GROUP	MODEL
Safety Recall Campaign	2011-2015MY Optima (TF)
NUMBER	DATE
SC284TF	May 2024

SAFETY RECALL CAMPAIGN

HECU MULTI FUSE REPLACEMENT (SC284TF)

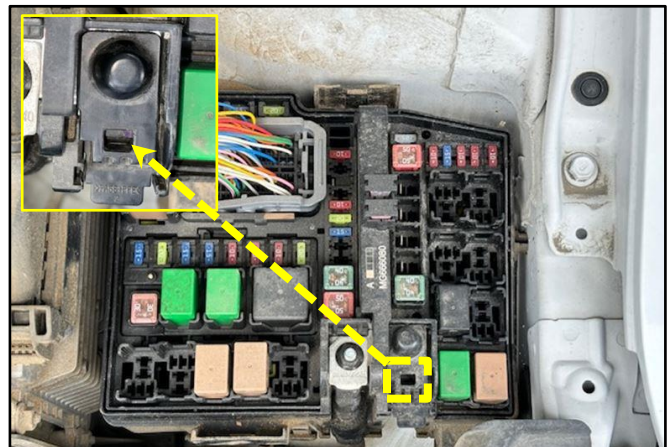
3. Remove and discard the junction box fuse cover.

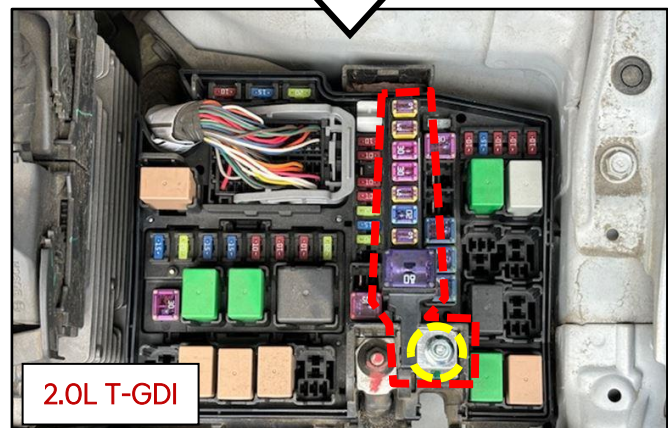
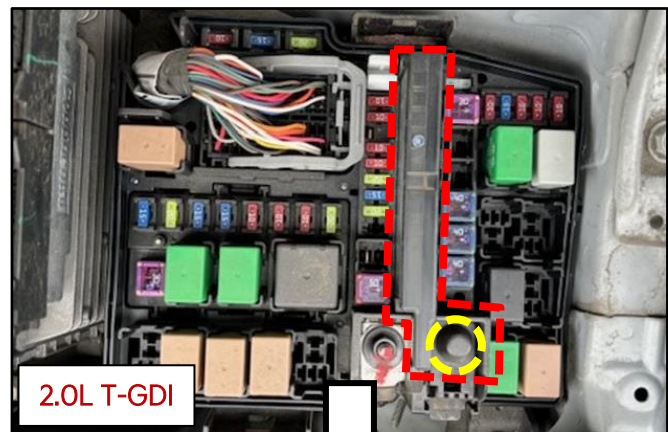
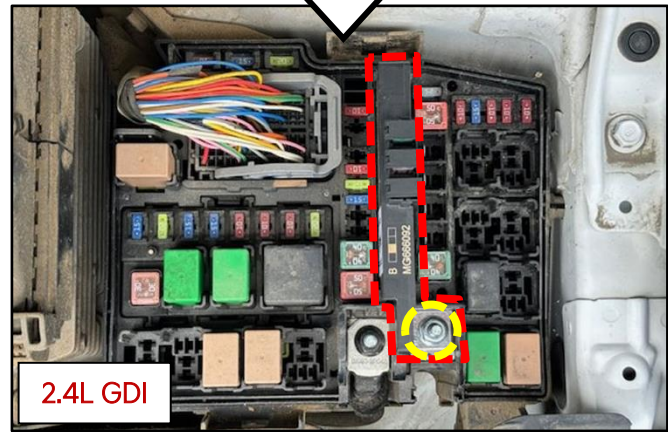
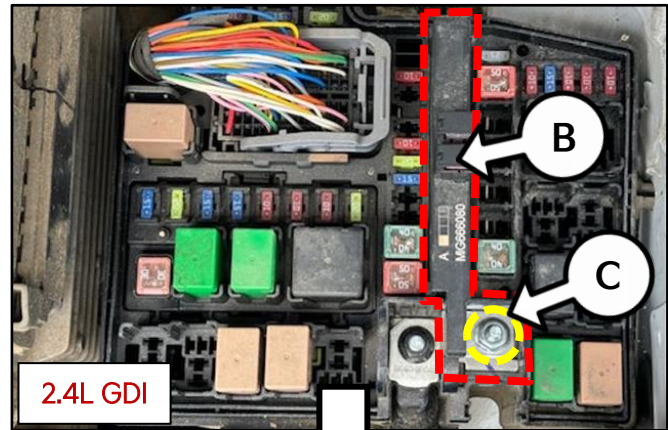
- 5a. Locate the Multi Fuse (B) for ABS1 and loosen the 10mm Multi Fuse retaining nut (C) and remove the Multi Fuse.
- 5b. Install the **new** Multi Fuse (B) and tighten the retaining nut (C).

Note: The Multi Fuse designs differ between 2.4L GDI and 2.0L T-GDI vehicles.

Note: Drill a hole through the center of the removed Multi Fuse. DO NOT reuse.

Tightening torque for retaining nut (B):
7.2 - 8.7 lb.ft (9.8 - 11.8 N.m)

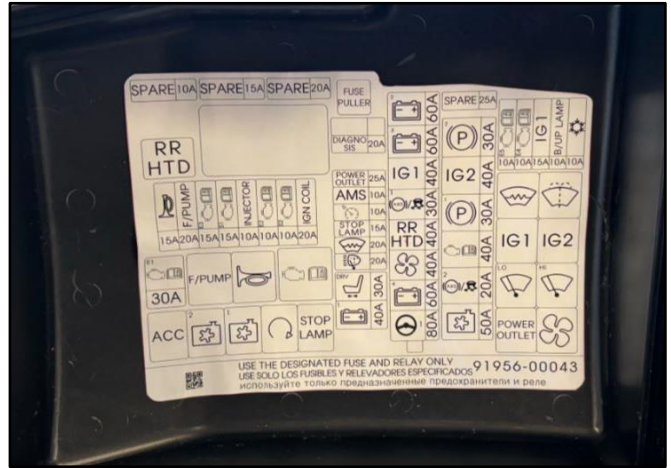
6. Adhere the new fuse label to the bottom of the new junction box fuse cover, as shown.
